Temperature sensors on APAs

Introduction

- Few problems have been observed in RTD kits sent to Daresbury and Chicago. Many apologies to both for the inconveniences
- Kits not yet installed have been returned to IFIC and are being carefully inspected and repaired
- The path forward
 - 1.Characterise observed problems
 - 2.Repair existing kits
 - 3.Changes in production procedures for new kits
 - 4.Changes in QA/QC procedures for repaired/new kits
- These items will be covered in this talk

Problem 5: Sensor cannot be plugged in 9/60

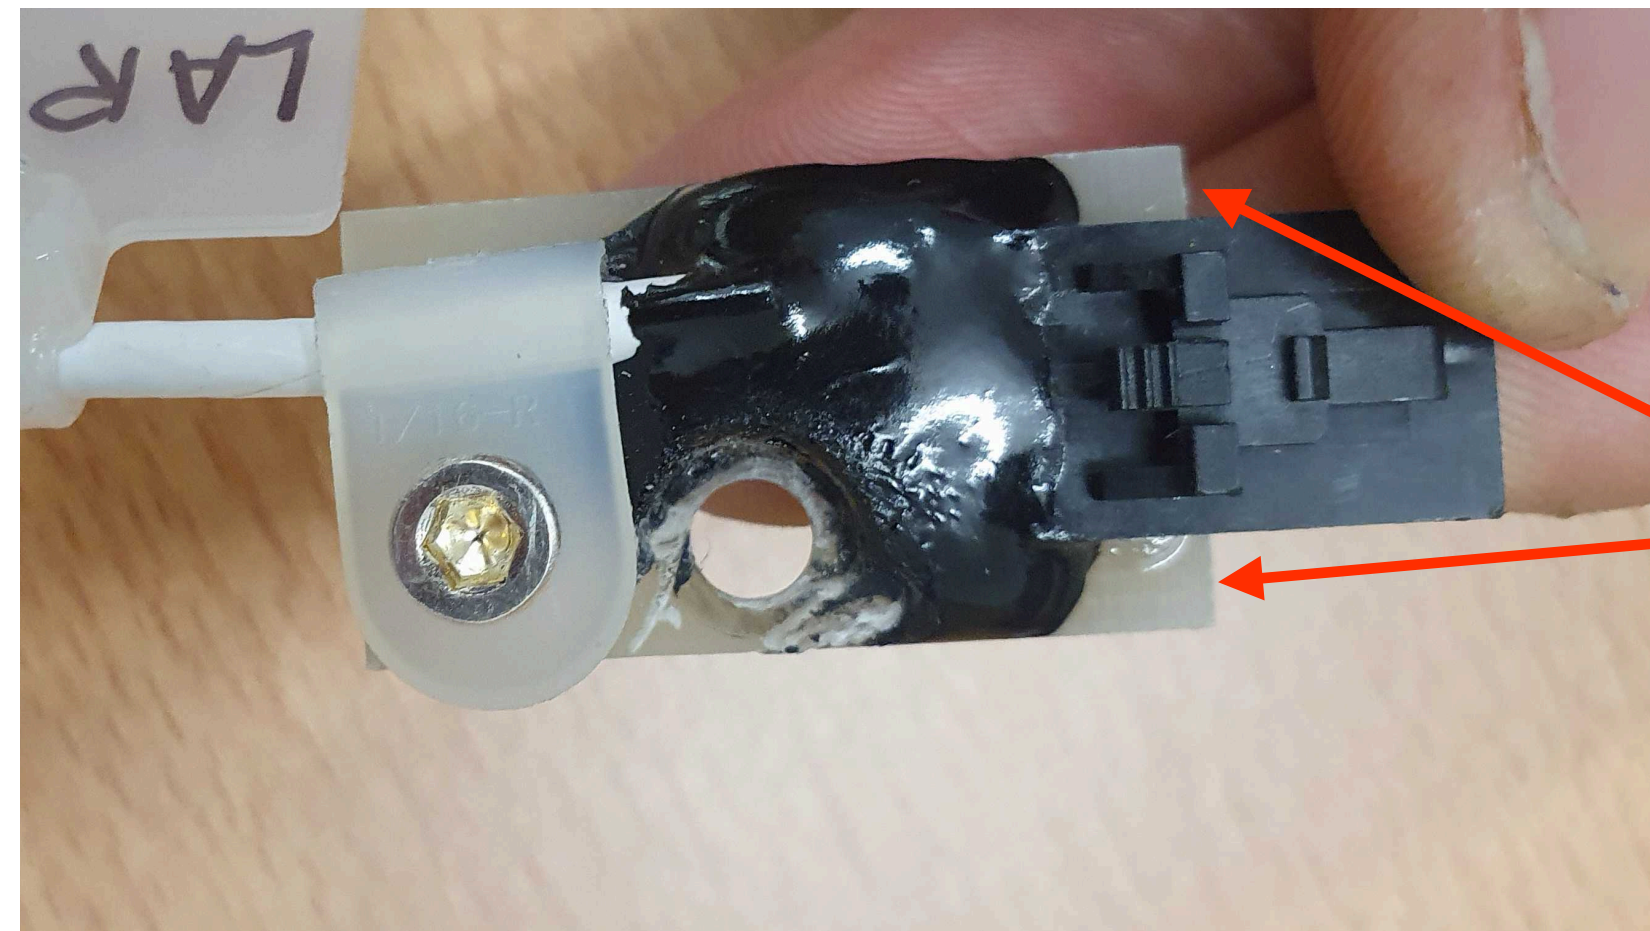
- In some cases the IDC-4 female connector is not correctly placed on the cable PCB (too much inside the PCB) and the sensor cannot be plugged in
- **Repair:** remove FR4 material with flat lime
- **Changes in production:** use new tool to correctly place the IDC-4 connector
- **Changes in QA/QC:** make sure RTD can be plugged in

Remove a bit of material in these two points

Problem 6: Cable blocking M4 screw

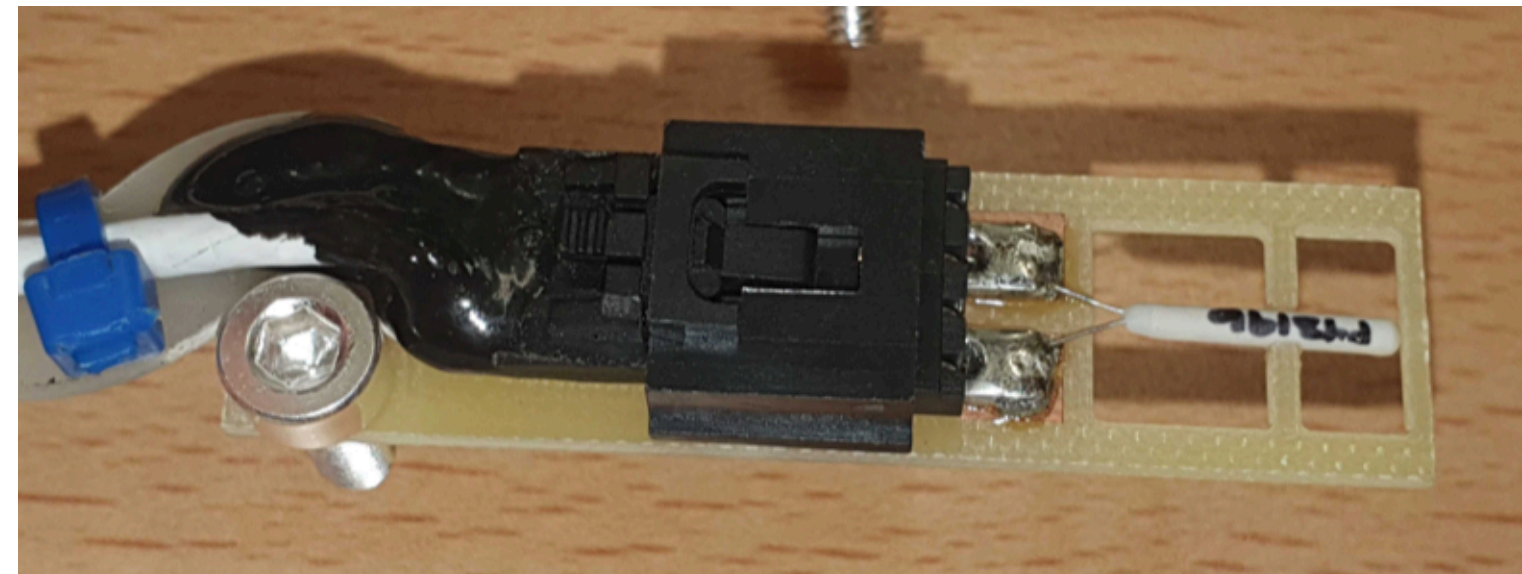
- For lower APAs there is no hole in the PCB. Instead a narrower PCB with the appropriate curve is used. Sometimes the cable prevents adding the M4 bolt
- **Repair:** There is no quick solution for this. The cable must be cut as close as possible to the edge and a new PCB and connector should be installed
- **Changes in production:** Correctly position the cable before epoxying. Add a bit of loctite super glue to fix the cable
- **Changes in QA/QC:** Mount entire kit with M4 bolt
